# STERLING RANCH FILING NO.2

### GRADING & EROSION CONTROL PLAN

CDR-20-005

SF-20-015

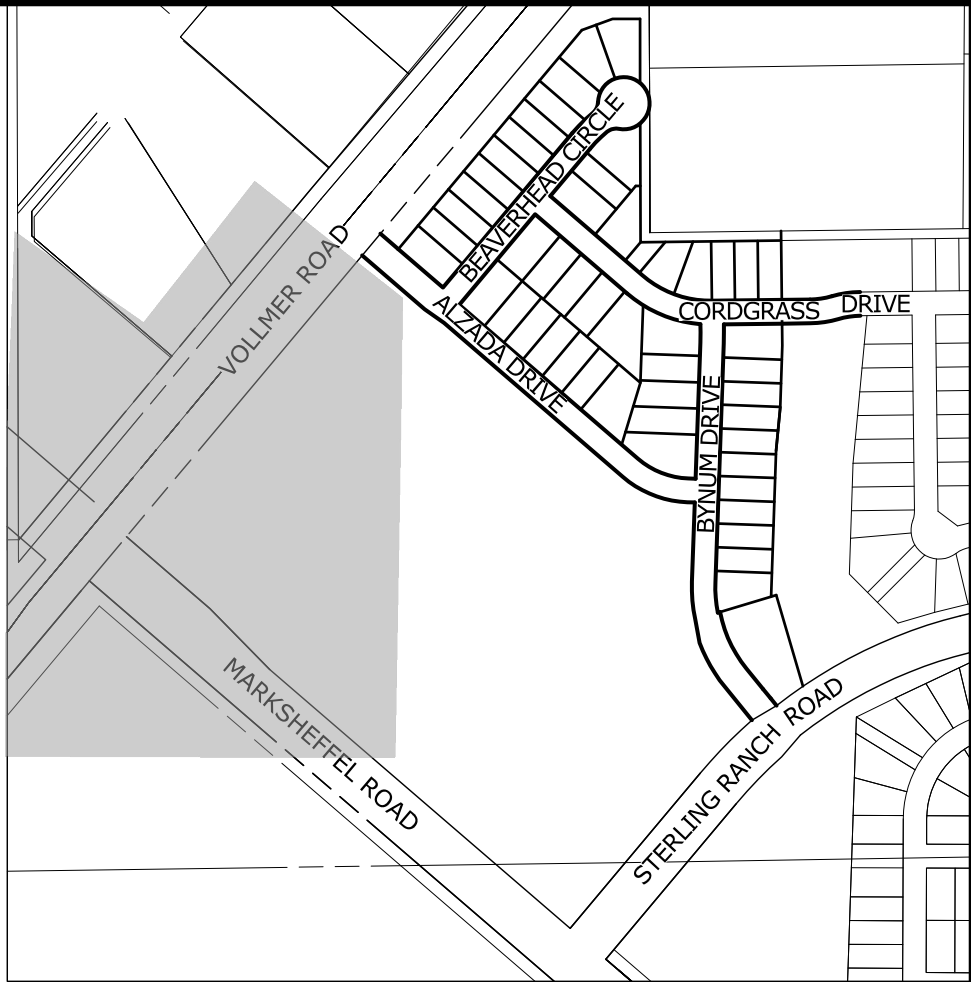
CWA should be away from the ditch

ROW doesn't seem wide enough for turn lanes...

show construction fence in legend

JR RESPONSE: CWA moved away from the ditch

JR Response: Future road now shown and R.O.W label adjusted

JR Response: Construction fence is now shown on the legend

STERLING RANCH FILING NO.2	GRADING & EROSION CONTROL PLAN	SHEET 3 OF 12
JOB NO. 25188.01

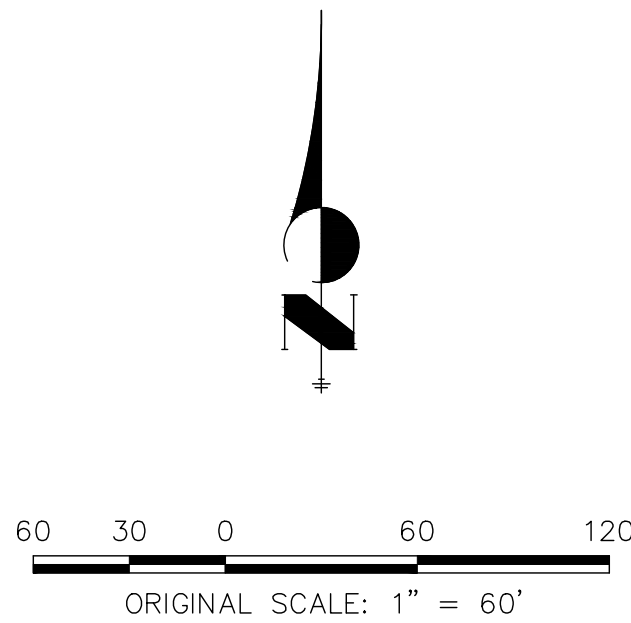
Is scale correct?

JR RESPONSE: Yes, scale was incorrect

SHEET 6 OF 12

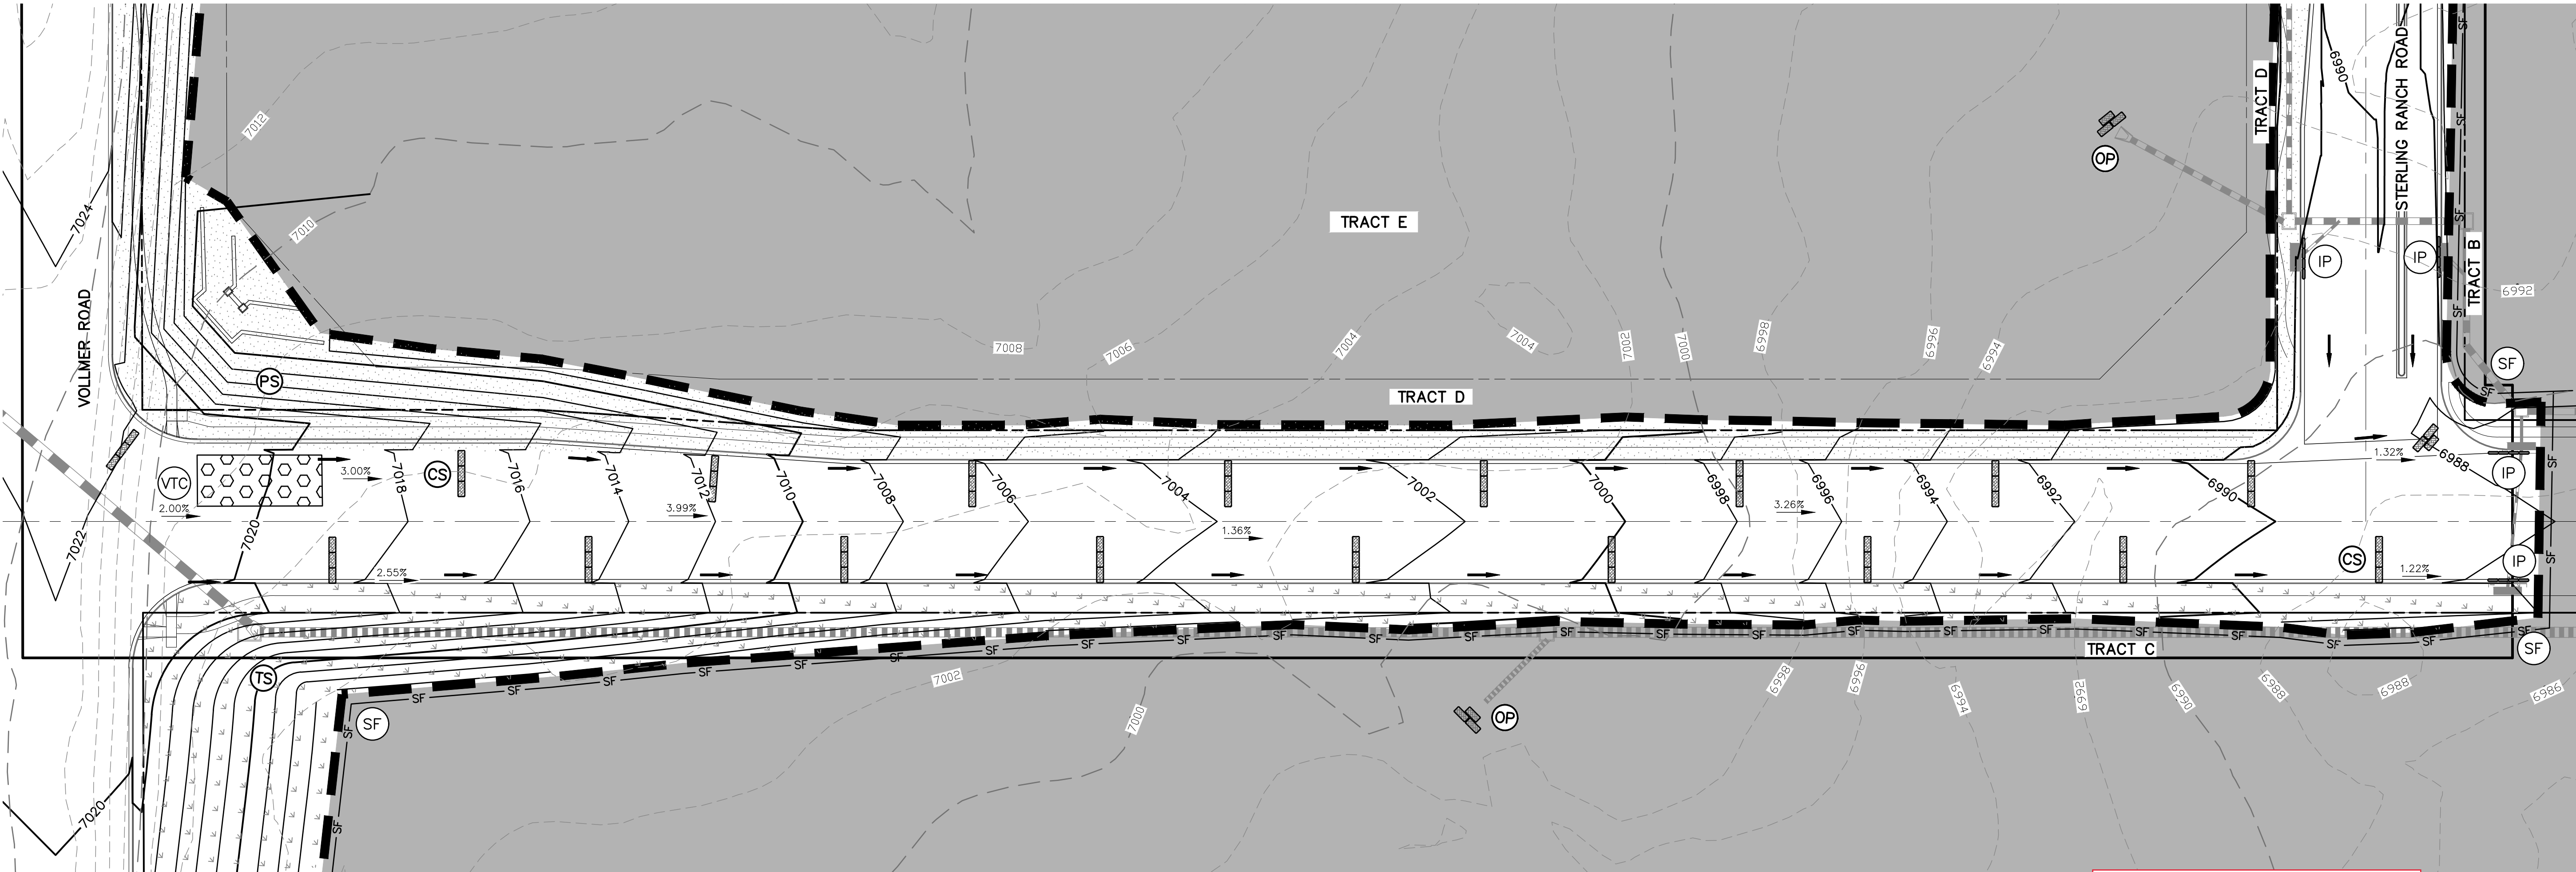
Final or Ultimate?

JR Response: "Final" Added
